JONES & BEACH ENGINEERS INC.

March 22, 2022

**RE: Response Letter 5 – Altus Engineering & Technical Advisory Committee
1169 and 1171 Sagamore Ave, Portsmouth, NH
Tax Map 224, Lots 14 & 15
JBE Project No. 21047**

C2

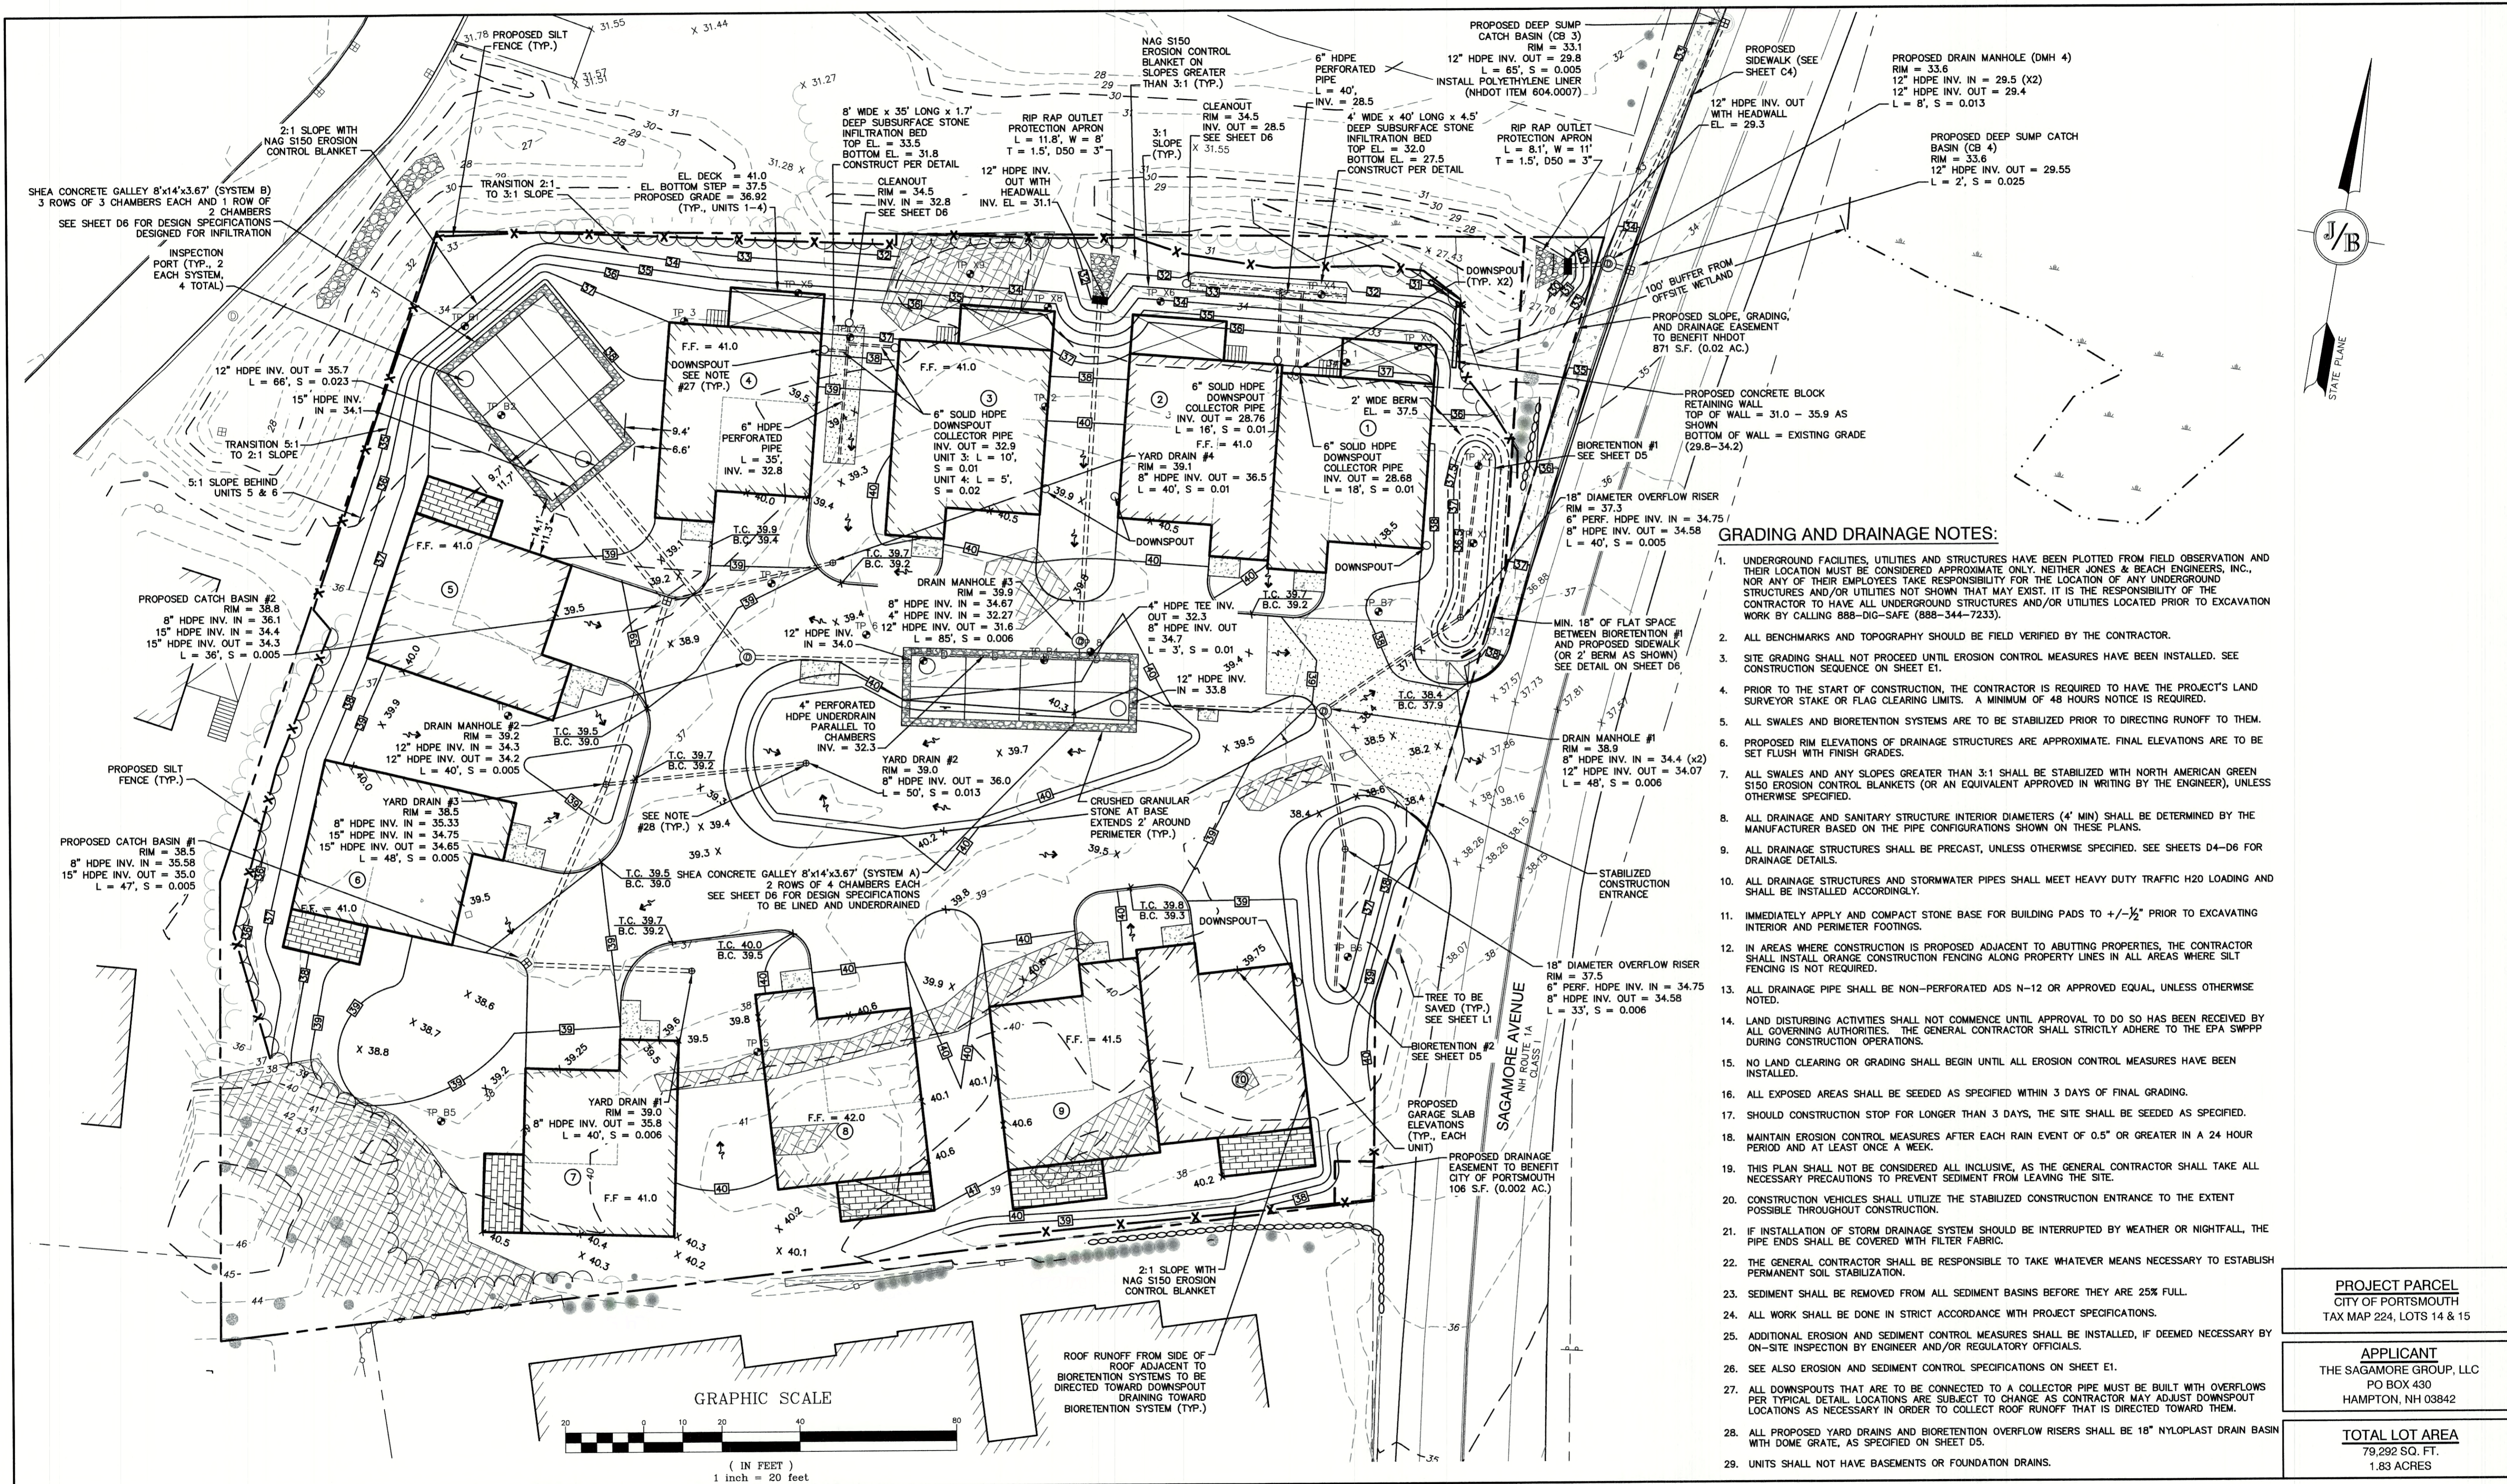
5. *The sidewalk on Sagamore is still labeled as 5' wide on the site plans. It needs to be at least 5.5' wide (concrete width) in order to meet current standards. Please change all plans for consistency.*

RESPONSE: The label on Sheet C2 has been corrected for consistency with the label on Sheet C4 and on the details.

SHEA CONCRETE PRODUCTS "GALLEY 8x14"

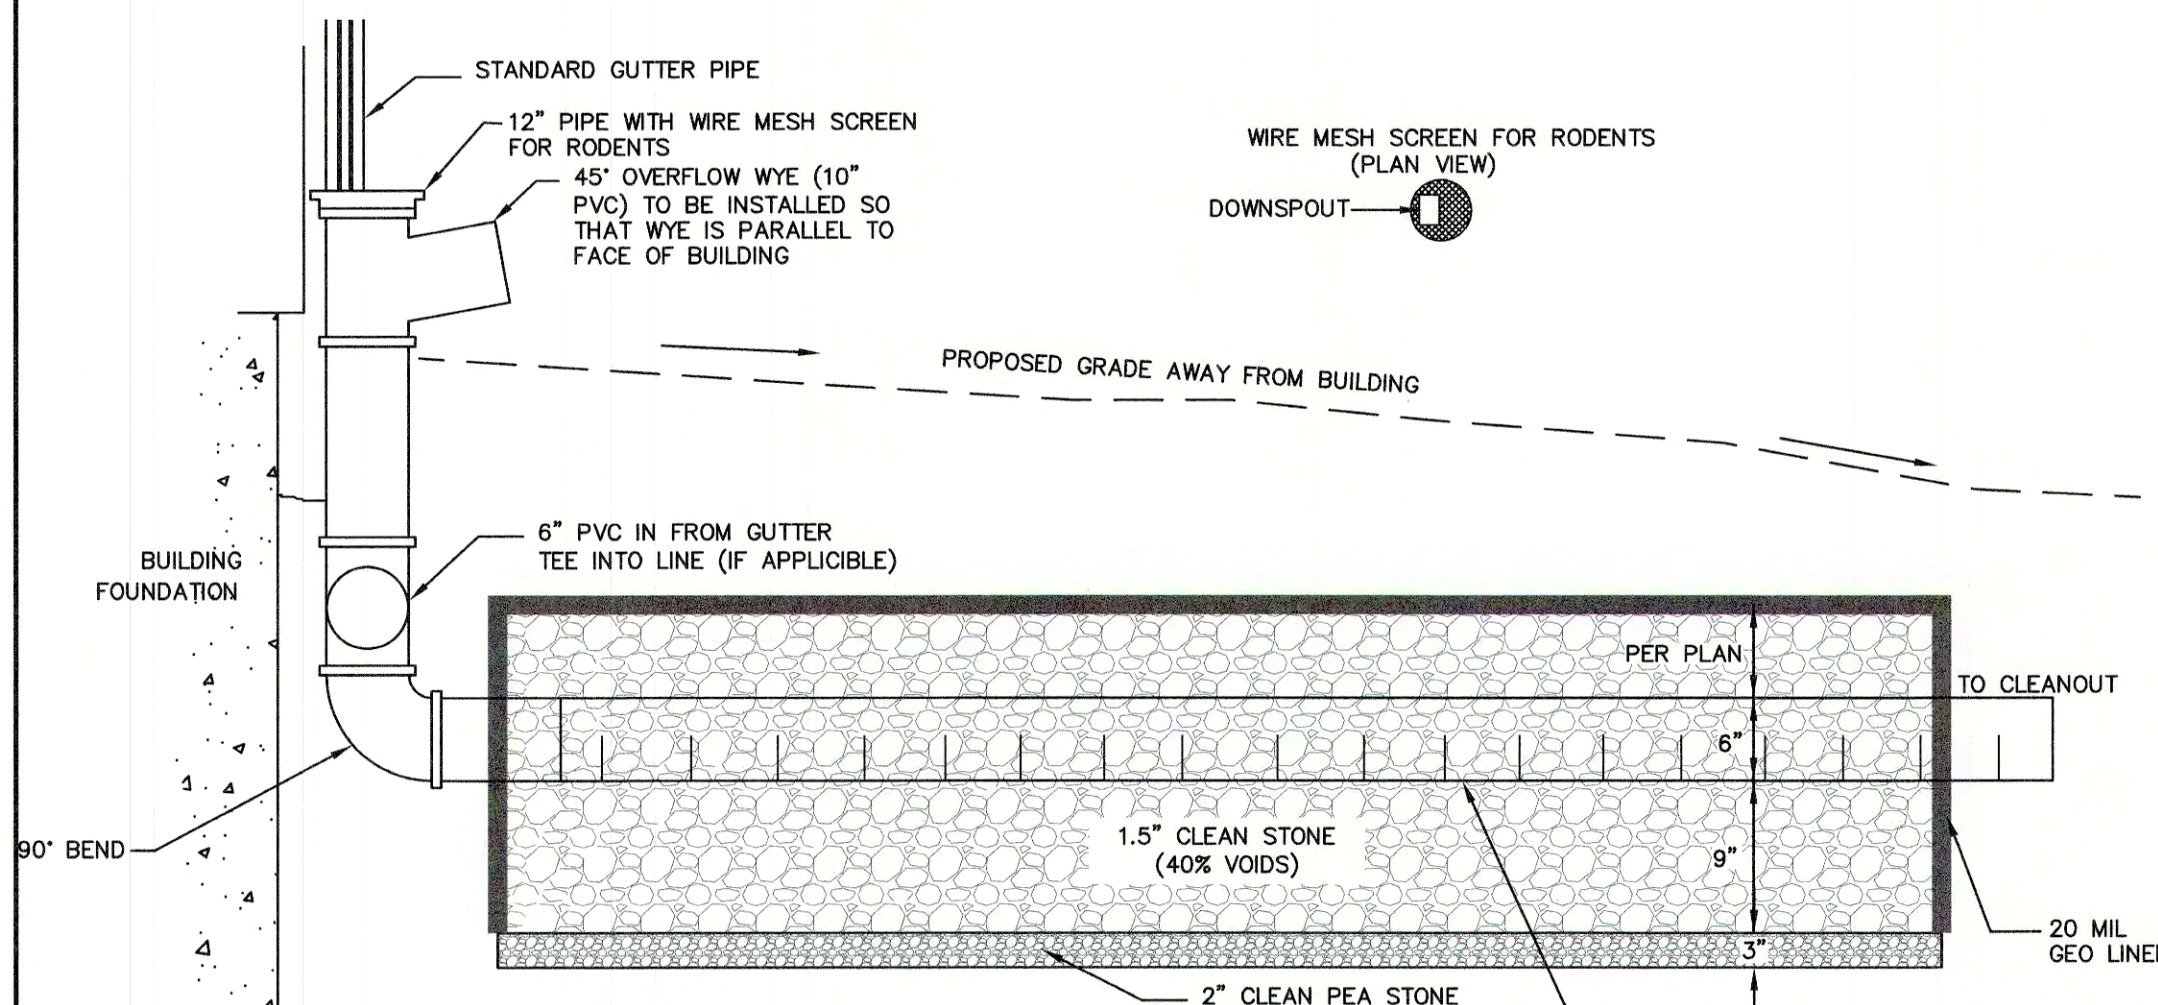
15. *The Shea Concrete products "galley 8 x 14" detail needs further clarification:*
- b. *Specification for the clay liner needs to be provided. Open issue. The Designer changed the material to a PVC liner. Crushed stone will be placed on the liner with the concrete galleys above. It is not clear if the liner can support the weight of the galleys without puncturing the liner.*

RESPONSE: This issue was resolved with the January 20, 2022 response letter as we have switched the liner specification to 36 mil polypropylene and provided puncture resistance calculations. We have further confirmed with Altus via email on 3/6/22 that they are satisfied with this approach.
